The True Cost of Renewables:

An Analytic Response to the Coal Industry's Attack on Renewable Energy

Blair G. Swezey and Yih-huei Wan

October 1995

Figure 1. RDI and EIA forecasts for delivered coal prices

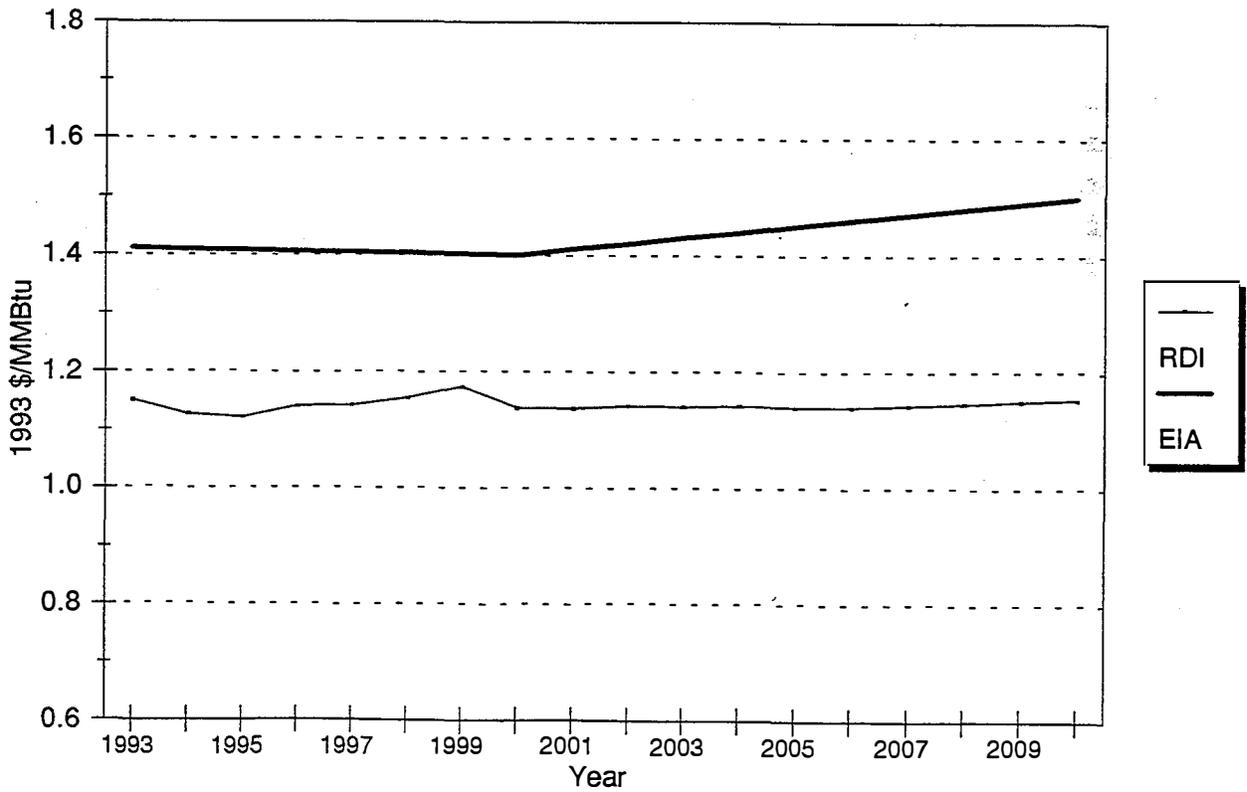
RDI utilizes a proprietary forecast for coal prices that is some 20% below cost projections from other sources. NREL substituted the latest coal price forecast made by the Energy Information Administration (EIA), the independent statistical arm of the U.S. Department of Energy (DOE).³ Figure 1 illustrates the differences in the RDI and EIA forecasts.
